## ADDENDUM

**Project:** Enger Tower Gazebo **Project No.** 10075.03  
**Owner:** City of Duluth  
**Architect:** Collaborative Design Group  
100 Portland Ave South, #100  
Minneapolis, MN 55454  
(612) 332-3654; FAX (612) 332-3626  
**Addendum:** No. 04 **Date:** 08/22/2011

TITLE SHEET

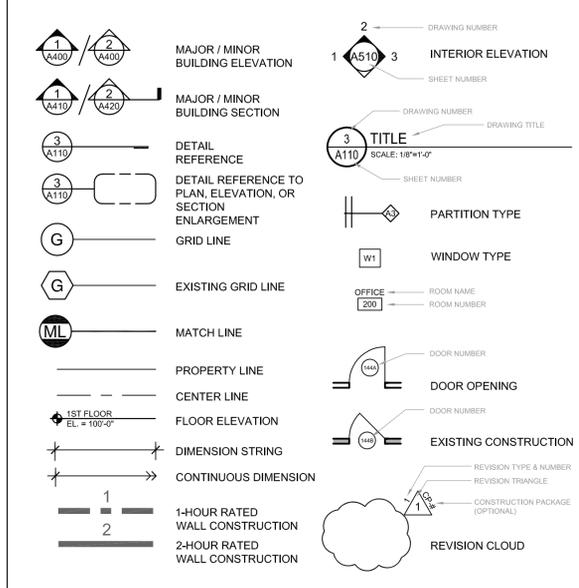
- Add list of Alternates; Add structural design responsibility note.

SITE PLAN

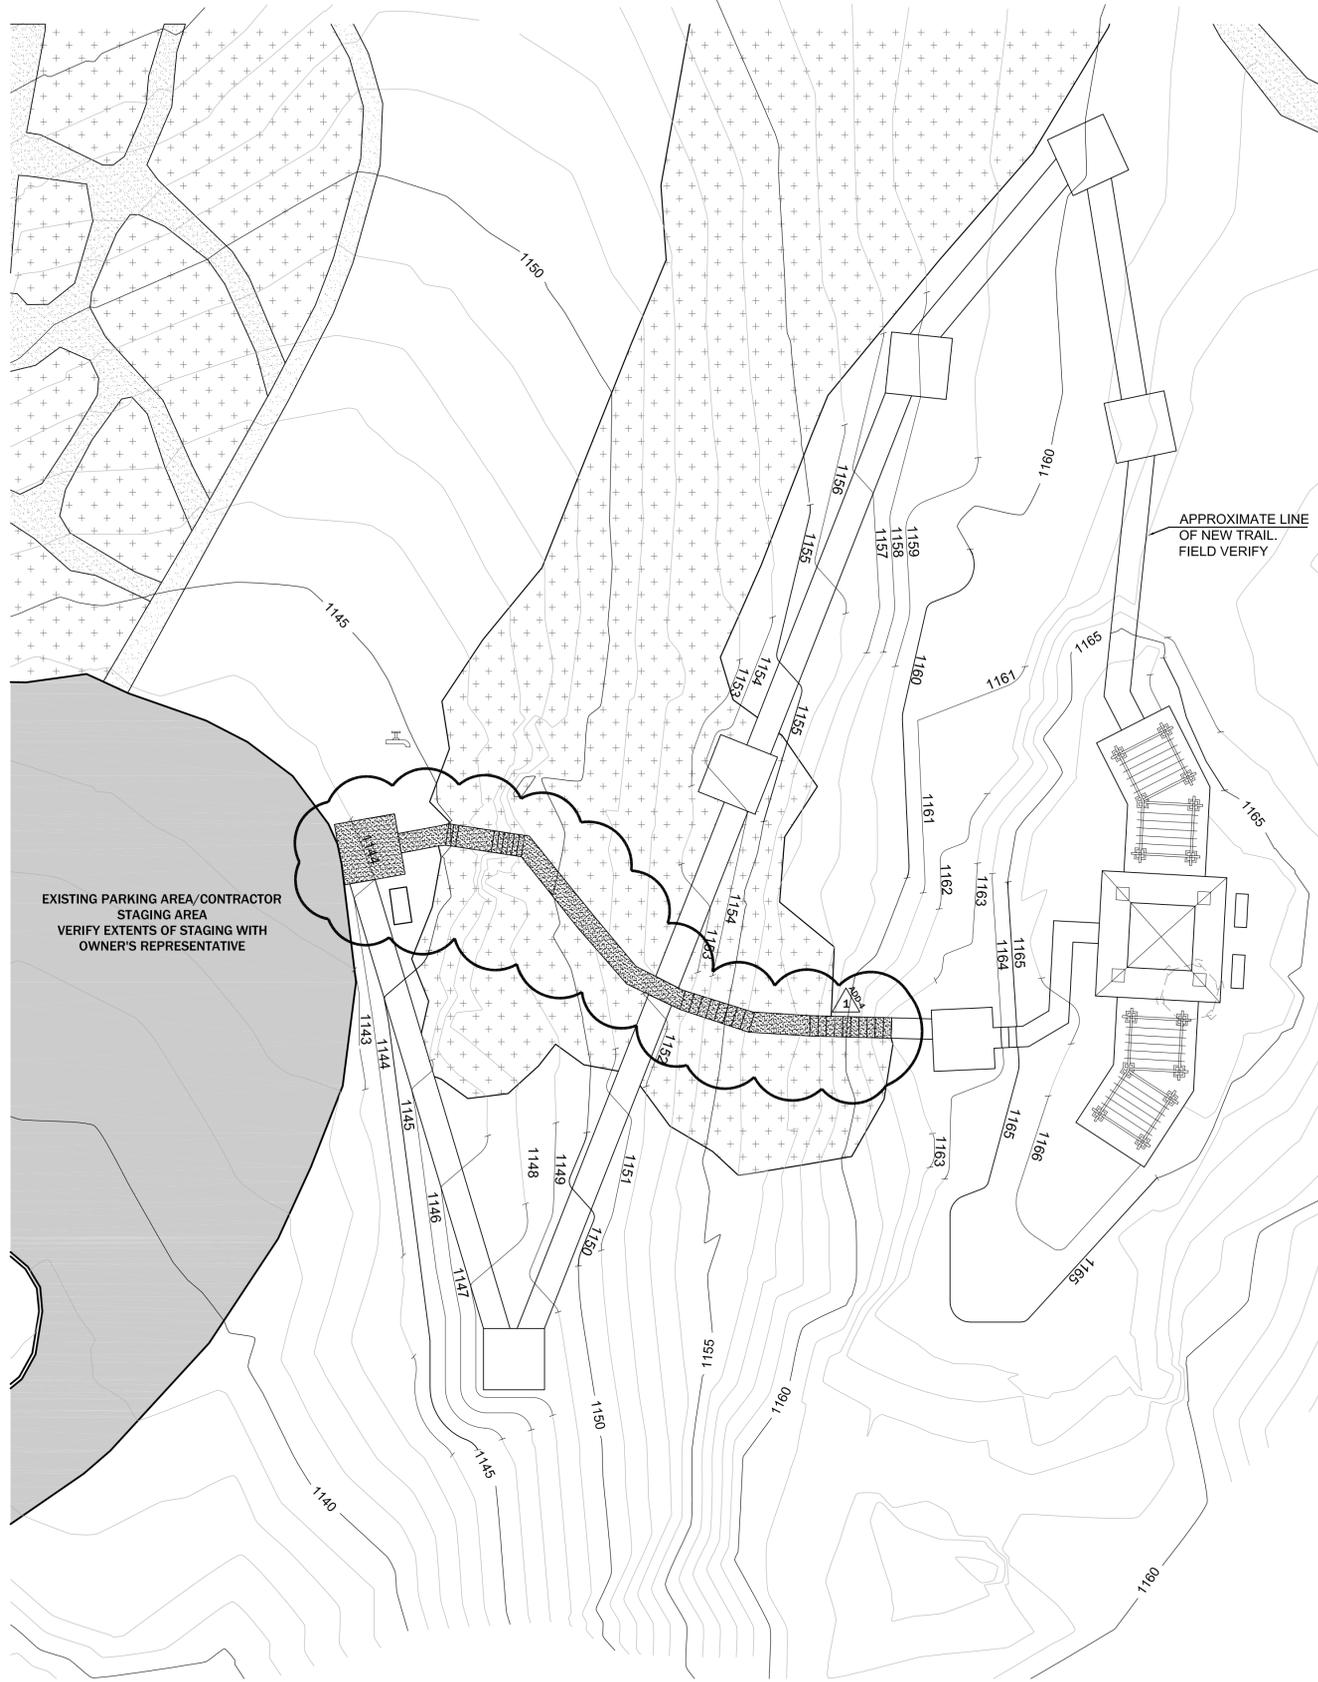
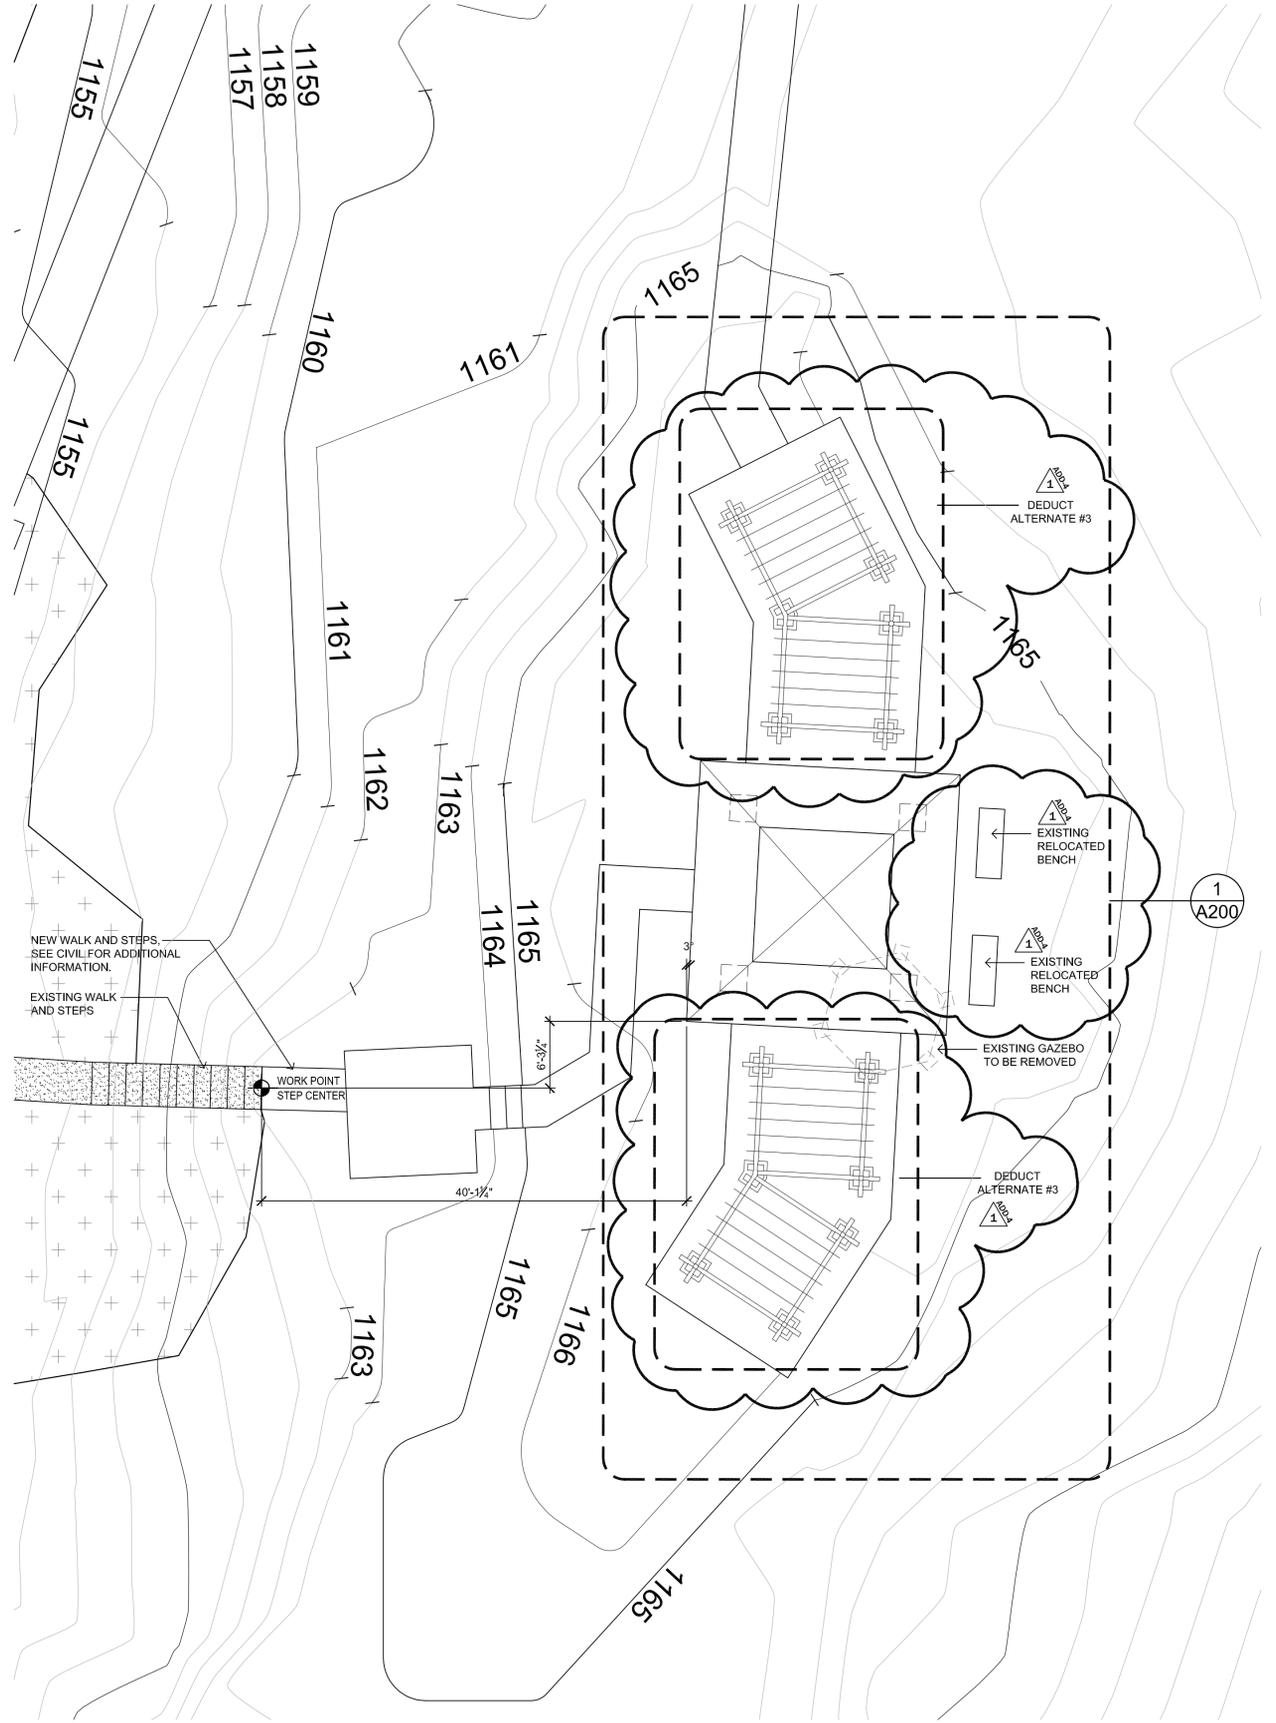
- Clarify extents of new and existing walks; note location of existing (relocated) benches; indicate pergolas as Deduct Alternate #3.

**1 FOUNDATION PLAN**  
 A200 SCALE: 3/16" = 1'-0"

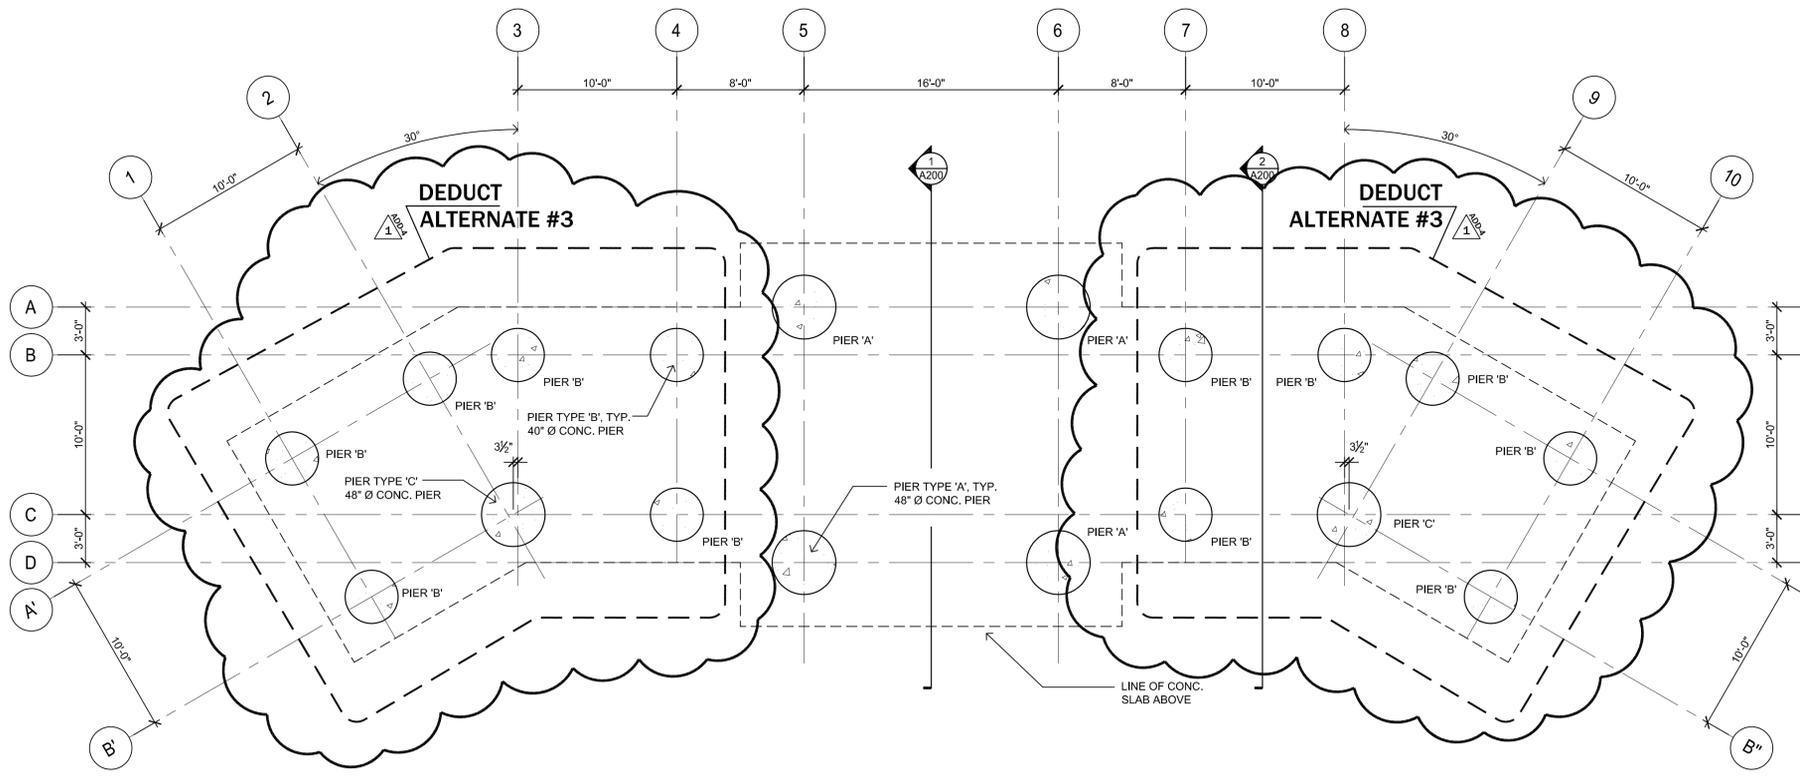
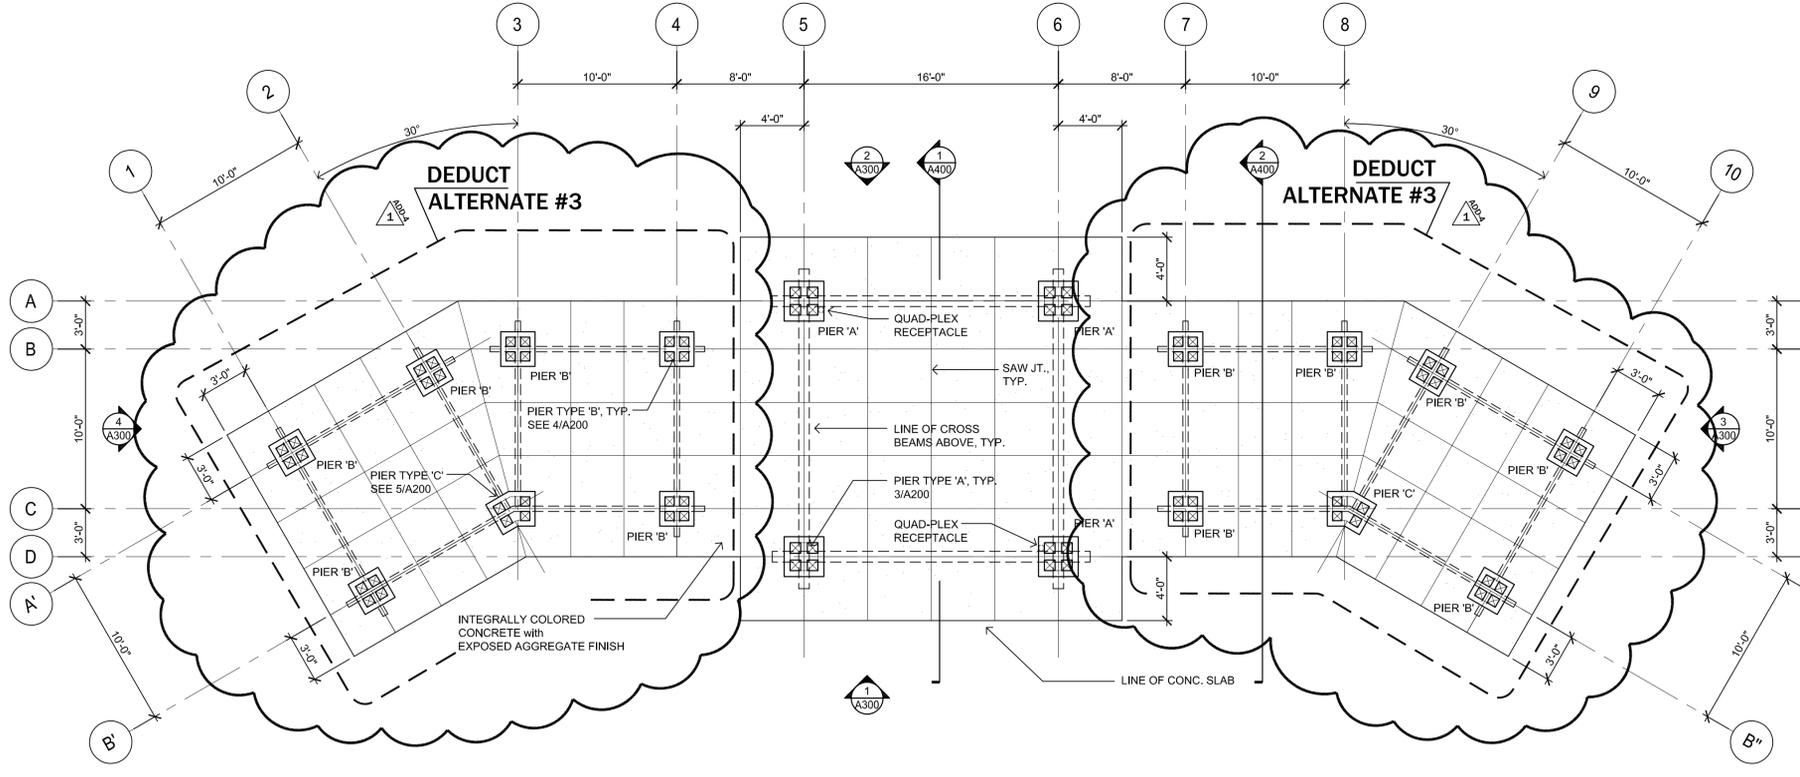
- Drawing 1 Foundation Plan – Add note designating pergolas as being Deduct Alternate 3;
- Drawing 2 Plan - Add note designating pergolas as being Deduct Alternate 3;
- Details 4 and 5 – Remove reference to rubble stone piers (stone caps to remain).

**1 WEST ELEVATION**  
A300 SCALE: 3/32" = 1'-0"

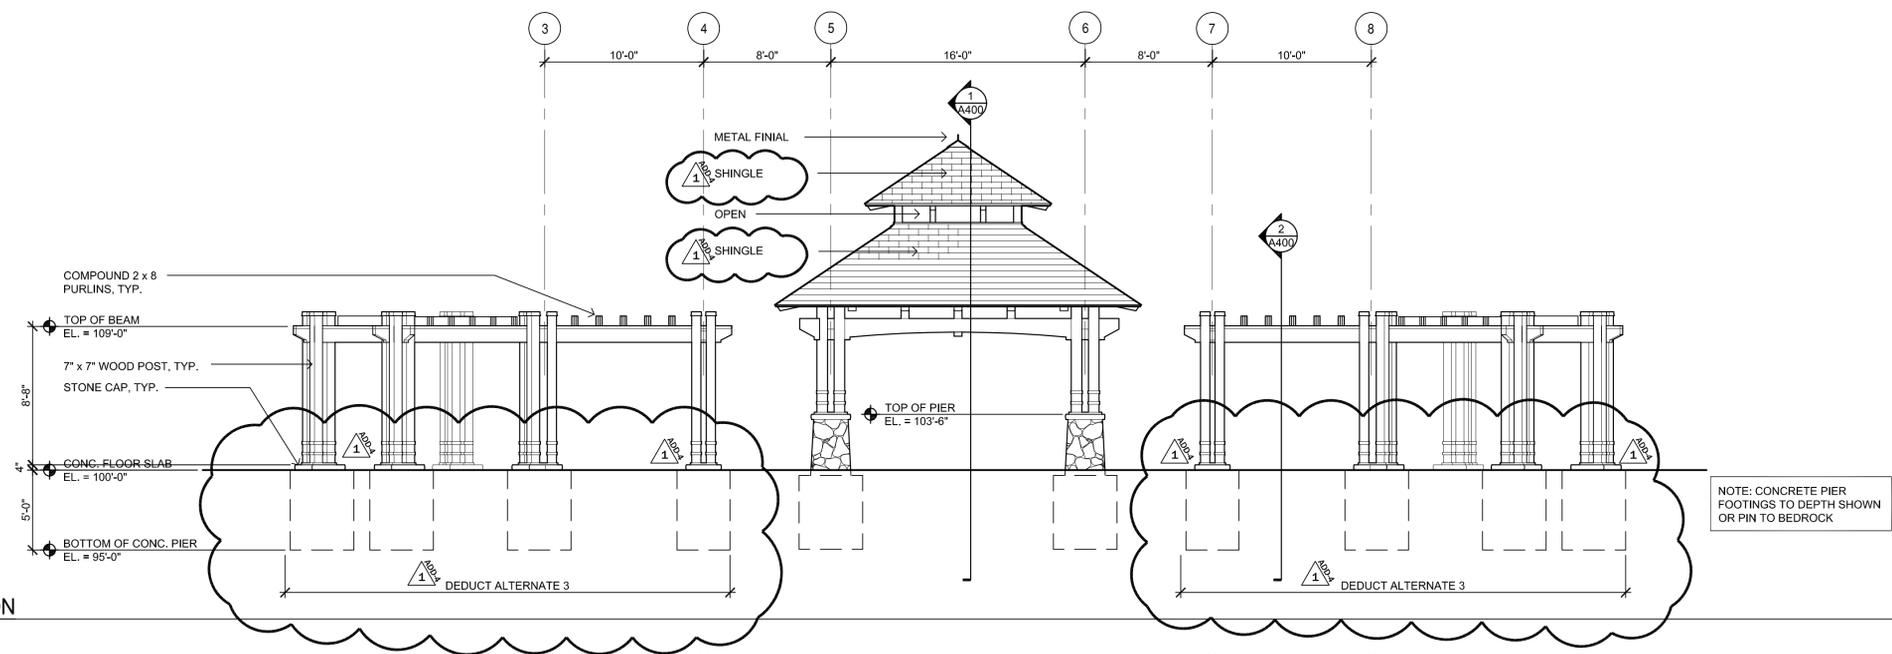
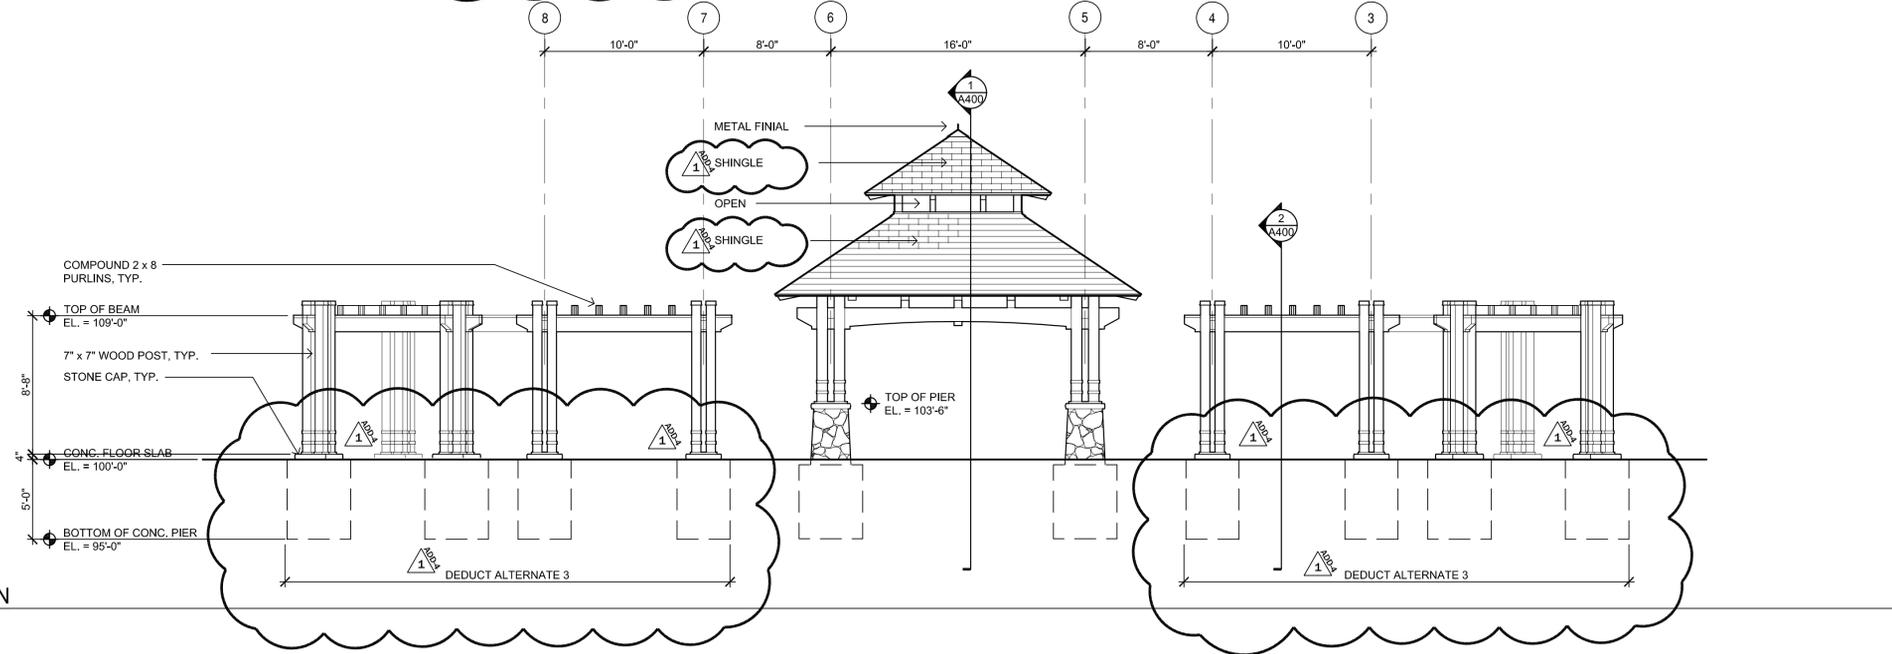
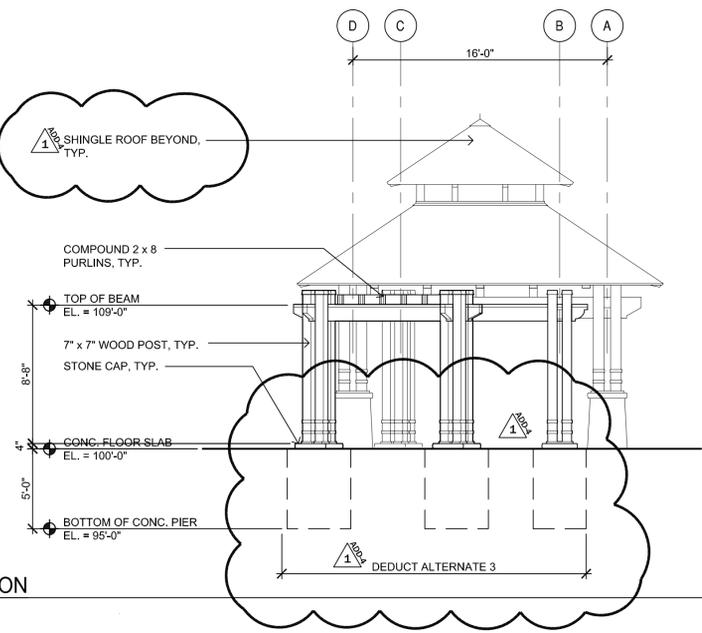
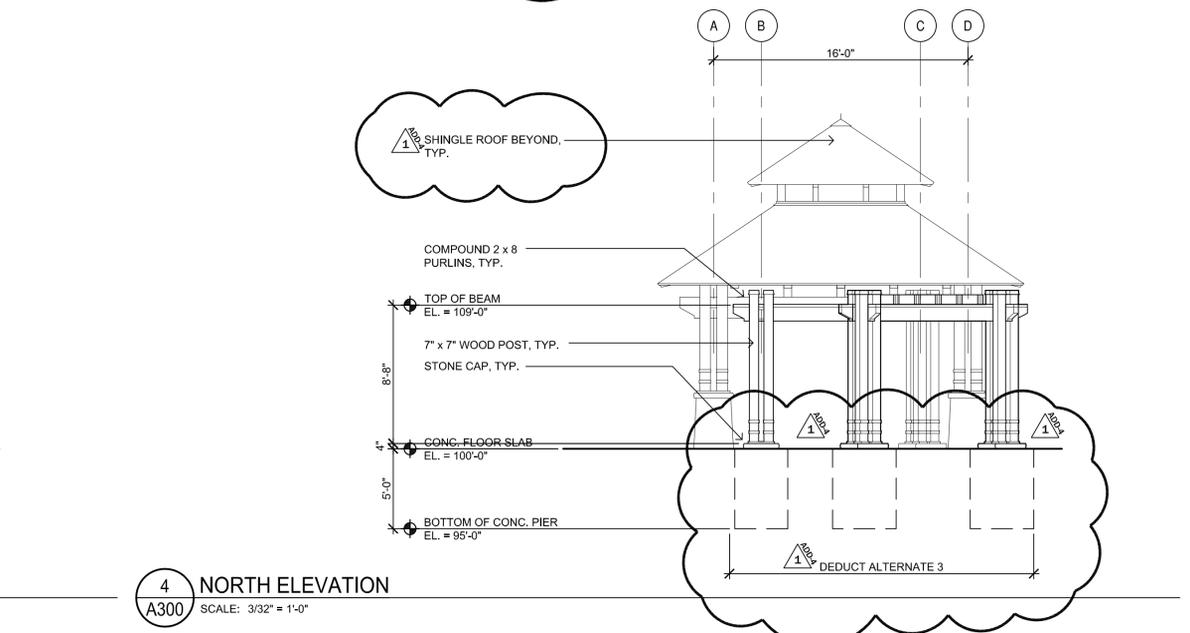
- Drawings 1, 2, 3, and 4 – Add note designating pergolas as being Deduct Alternate 3; remove “Metal” reference at shingles; modify pergolas to indicate elimination of stone piers (stone caps to remain).
